**TOWNSHIP OF SOUTH WHITEHALL
LEHIGH COUNTY, PENNSYLVANIA**

PLANNING COMMISSION

MAY 18, 2023

**SUBJECT: BLUE BARN ROAD SUBDIVISION
MAJOR PLAN 2020-107
REQUEST FOR SKETCH PLAN REVIEW**

PLAN TITLE: SKETCH PLAN
PROJECT TITLE: BLUE BARN SUBDIVISION

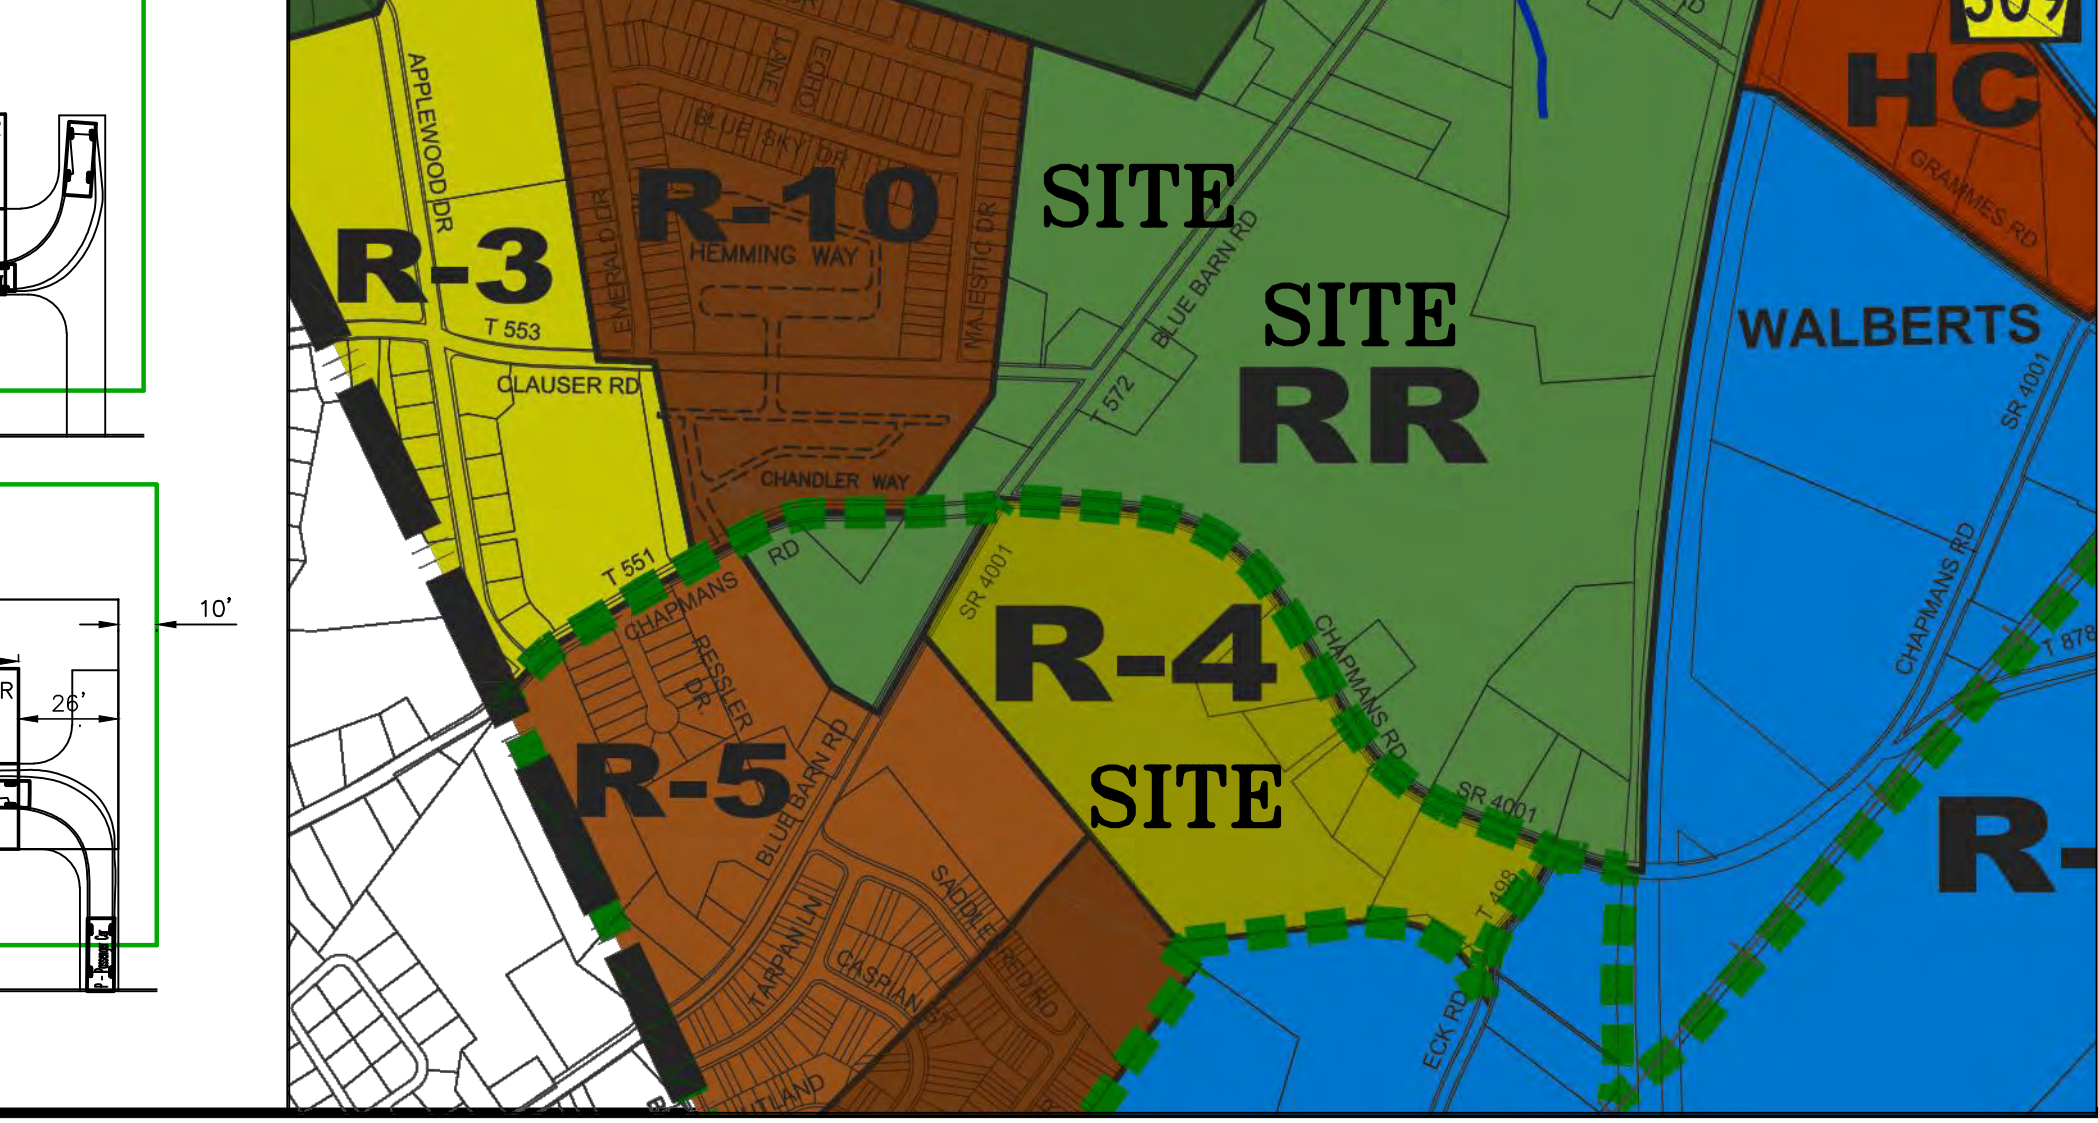
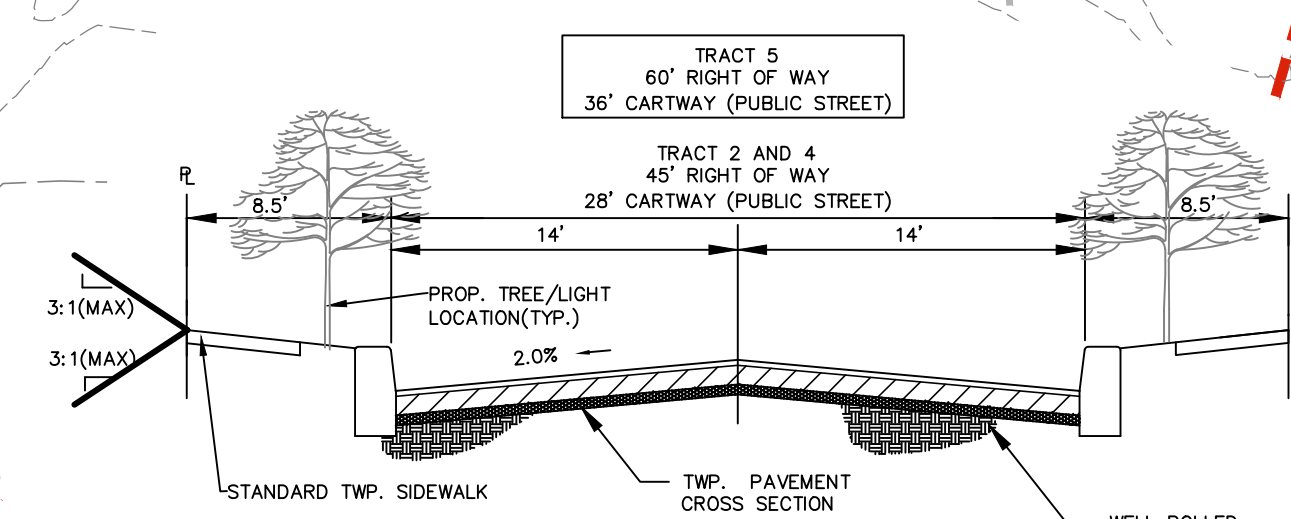
3. **Zoning § 350-24(c)(7)** – The Site Data table for the R-5 zoning district lists incorrect side and rear yard setbacks for Two-Flat uses. It is noted that the plan does not propose two-flat uses, but this table shall be revised for accuracy.

5. **SALDO § 312-10.B.(4)** – A signed statement that the applicant is the owner, or authorized by the owner to make application for the land proposed to be subdivision shall be included on the Sketch Plan.

6. **SALDO § 312-10.B.(5)(a)** – The gross areas listed for each tract do not match the acreages on the provided deeds. Please clarify.
7. **SALDO § 312-10.B.(5)(d)** – The type of water supply system shall be provided on the Sketch Plan.

8. **SALDO § 312-10.B.(5)(e)** – The type of sewage disposal system(s) shall be provided on the Sketch Plan.
9. **SALDO § 312-10.B.(5)(h)** – The required number of parking spaces, impervious coverage, and driveway separation measurements shall be provided on the Sketch Plan.

10. **SALDO § 312-10.B.(6)** – A location map showing the general location of receiving streams shall be provided on the Sketch Plan. In addition, it is noted that the USGS StreamStats website delineates an unnamed tributary that has headwaters near the intersection of Blue Barn Road and Chapmans Road and flows to the northeast

11. **SALDO § 312-10.B.(9)** – Proposed lot and street layout with dimensions of lots and street rights-of-way to the nearest foot shall be provided on the Sketch Plan.

12. **SALDO § 312-10.B.(10)** – Property boundaries within 200 feet of the site shall be shown. It is also noted that it appears that the High Vista Drive right-of-way terminates at the boundary of Tract 1 and shall be shown accordingly on the Sketch Plan. In addition, Chandler Way and the associated right-of-way shall be identified on the plans.

13. **SALDO § 312-10.B.(11)** – Sequential staging (phasing) of development within the subdivision shall be provided on the Sketch Plan.
14. **SALDO § 312-10.B.(12)** – Limits of existing woodlands and any other natural features shall be shown on the Sketch Plan.

17. **SALDO § 312-35.A.(6)(c)** – Intersections shall intersect at 90°. It appears that the Road 5-1/Road 2 intersection with Chapmans Road is less than 90°. This should be revised.

18. **SALDO § 312-35.A.(6)(e)[1]** – Centerlines of intersecting streets shall be offset a minimum of eight hundred feet (800') from the nearest intersecting street along arterial streets. It is noted that Blue Barn Road and Chapmans Road are both classified as Minor Arterial roadways on the Official Map of South Whitehall Township. The following proposed intersections have less than the required offset from adjacent streets and shall be revised accordingly:

20. * **SALDO § 312-35.B.(2)(b)[1]** – Dead-end streets, other than stub and cul-de-sac street, shall be prohibited. Road 5-1 is proposed to extend beyond the intersection with Road 5-4 and dead-ends. In addition, a stub street is proposed at the terminus of Road 5-4 and ends at the edge of the adjacent property to the south. The Planning Commission should review the proposed dead-end street and stub street and may wish to provide comment.

21. * **SALDO § 312-35.B.(2)(b)[2]** – To provide an integrated street system, all stub streets of abutting subdivisions shall be incorporated into the proposed street system. It is noted that High Vista Drive is a stub street that appears to abut Tract 1. The Planning Commission should review the potential to connect to High Vista Drive and may wish to provide comment.

28. **SALDO § 312-35.B.(3)(b)[1]** – Arterial streets (Blue Barn Road and Chapmans Road) shall have a eighty-foot (80') right-of-way and a fifty-foot (50') cartway. Right-of-way should be dedicated along Blue Barn Road and Chapmans Road. The plan appears to show a dedicated right-of-way of 60' along Blue Barn Road and Chapmans Road.

29. * **SALDO § 312-35.B.(3)(d)[1]** – Local street cross sections shall be in accordance with Township standard construction documents (latest revision). It is noted that the proposed Typical Street Cross-Section for Tract 5 includes a 60' wide right-of-way and 36' wide cartway in accordance with the Local Streets Typical Cross Section. The plan proposes a 45' wide right-of-way and 28' wide cartway within Tracts 2 and 4 on the Typical Street Cross-Section. This alternative typical street cross section may be permitted with prior approval by the Township staff. Township staff should review to determine the acceptance of the alternative street cross section.

58. * **Section § 296-38** – The Sketch Plan shows a total of six (6) potential stormwater management areas. Five (5) areas are located on non-building lots that also include adjacent open space areas to be dedicated to the Township. The remaining area, located on Tract 2, straddles Lots 3 and 4. The Township Staff and the Planning Commission should review and may wish to comment on their preference for stormwater facilities to be dedicated to the Township. It is recommended that stormwater facilities be contained on a single lot.

- 62. The Plan depicts the realignment of the Chapmans/Blue Barn Intersection to eliminate the existing offset alignment of Chapmans Road. Detailed Geometry plans should be provided for review by the Township and PennDOT.

- 64. The driveway located to the south of the Road 5-2 intersection with Blue Barn Road should be shown on the plans.
- 65. It is recommended that Lot 5 on Tract 1 have restricted access to Clauser Street.

- 66. The applicant should clarify the intended use on Tract 3.
- 67. The applicant should clarify the intent of the subdivided parcel of land on Tract 5 that is located between the two existing dwelling that abut this parcel.
